NEW Recall Campaign 10V-331: Fuel Level Sensor

NEW F10 (5 Series) All models produced from January 12, 2010, to July 1, 2010

NEW F07 (Gran Turismo) All models produced from January 12, 2010, to July 1, 2010

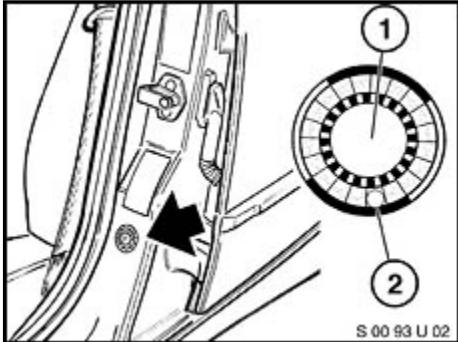
Interference between the fuel level sensor float and the internal corrugated ventilation line inside the fuel tank

Remove and replace the previously installed right-side fuel level sensor using P/N 16 11 7 297 340. For replacement procedures, refer to Repair Instruction REP 16 12 000 Removing and installing/replacing sensor for fuel gauge.
